Our ref: JB/2408
Your ref: H09-0442-25

**RE: LAND OFF BATTLEFIELDS LANE SOUTH HOLBEACH SPALDING
PE12 7PG**

Outline application:

Image 2: Image of Pipe termination point.

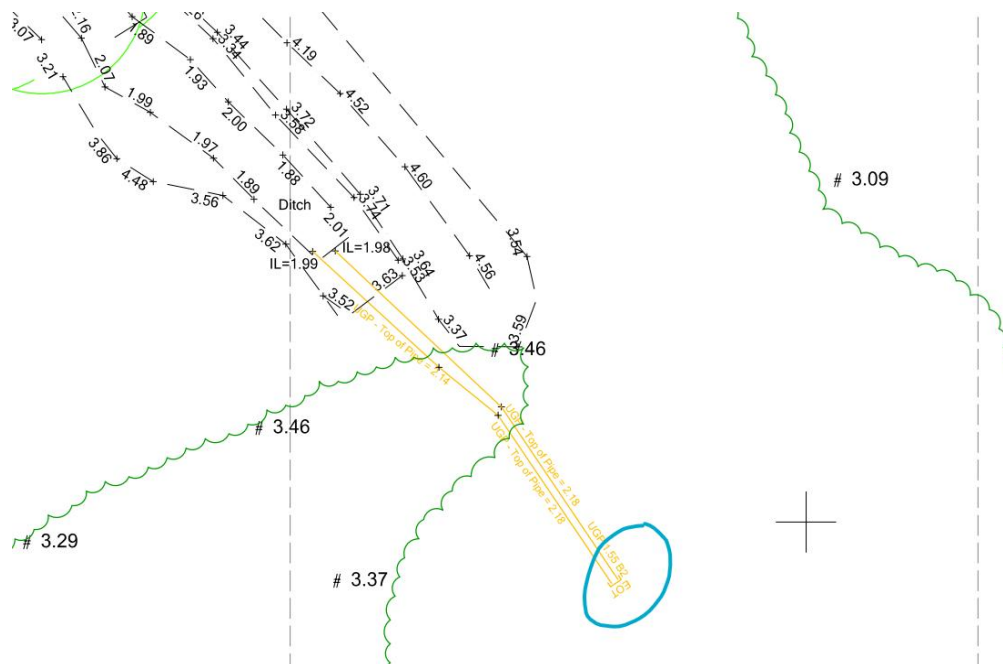
As you know the Drainage Board objected to the proposal and you have amended the illustrative layout in the Outline application to remove houses where they were above the IDB assets, but it would be useful to address all their points so that I can reconsult them (appreciating that it is not a requirement for you to apply for consents at this stage, but so I am satisfied that the development would meet their requirements). Their comments are attached.

In relation to point 2), there is no issue with the IDB carrying out a site visit to look at any exposed field drains. The Drainage Consultant has advised that the CCTV and topographic survey completed in respect of the 2021 application (ref. H09-0115-21) is shown below:

From previous discussions, the Drainage consultant is aware that the CCTV Team attended the site but were unable to undertake a survey as the pipe had collapsed. They returned once the ecology and arboricultural teams had cleared an area of dense vegetation, permitting them to excavate along the length of the pipe. At the EOT point marked on the topographic survey (Image 1), the pipe terminated (Image 2).

The Drainage Consultant has advised that all evidence points to the pipe being severed when the housing development to the south was built. The original drainage strategy put forward as part of the 2021 application proposed discharging the eastern-most parcel to the central ditch. At that time, an objection was received from the IDB, stating that the ditch had no onward connectivity. It was this objection which triggered the site investigations in an attempt to understand whether the ditch was connected to the Foxes Low drain. However, the investigations could not prove any such connection existed. To overcome the objection, the Drainage Consultant had to then change the layout to provide an alternative discharge location.
